Olive Downs Coking Coal Project

Additional Information to the
Environmental Impact Statement

Section 21

**Impact Avoidance
and Minimisation**

**Figure 21-1
ODS9 Design with and without the Proposed Ripstone Creek Diversion**

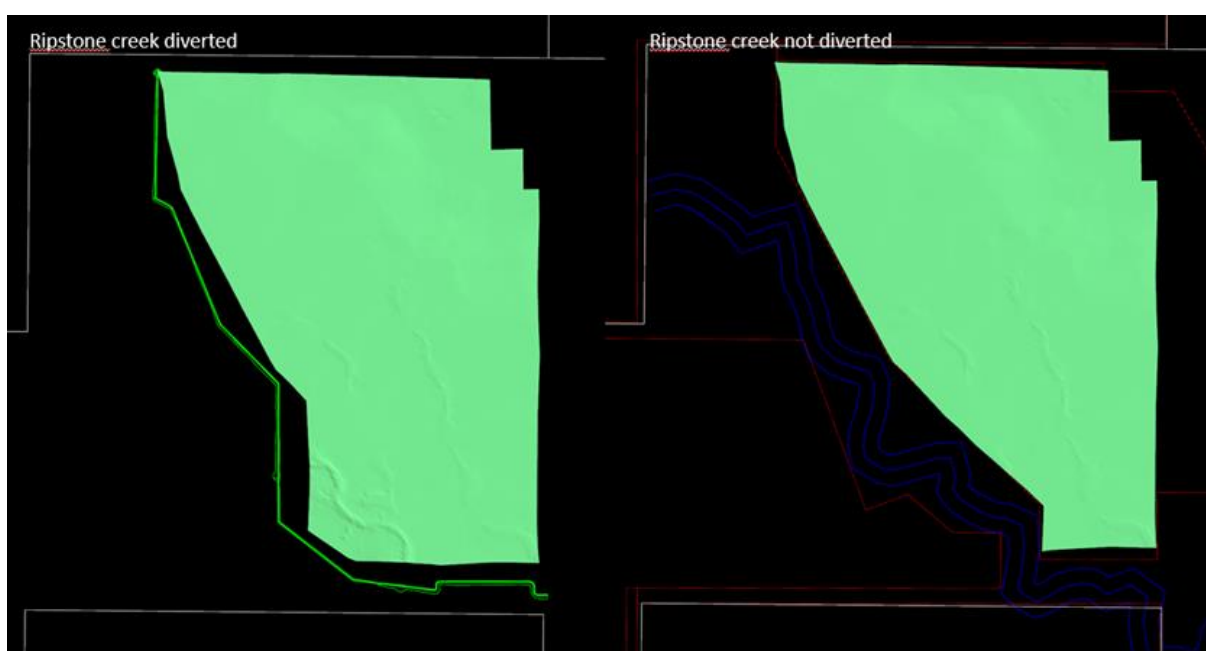
1. Describe the economic and operational impacts to the project of not diverting Ripstone Creek

The principal economic cost of avoiding Ripstone Creek centres around the loss of product coal. Avoiding Ripstone Creek would necessitate the reduction in extent of mining the ODS9 open cut pit (ODS9).

An assessment of the potential loss of ROM coal has confirmed that approximately 3 million tonnes of ROM coal would remain in-situ, as shown on Figure 21-1.

Reducing the extent of ODS9 would impact the efficient extraction of the coal resource in ODS9, which would have flow on effects to other parts of the mining operation. In particular, as the width of the southern part of the pit would be reduced, the available space for active mining in this area would be reduced. This would reduce the rate of mining and therefore reduce the rate of production in this pit. To maintain the Project's proposed production profile, the mining intensity within other parts of the mine would have to be increased to account for the reduction in production from ODS9. This would require larger areas of the open cut pits to remain open (to accommodate the additional mining fleet required to sustain a higher intensity) and would therefore require larger out of pit waste rock emplacement areas as there would be less space for in-pit waste rock emplacement, increasing the overall disturbance footprint of the Project.
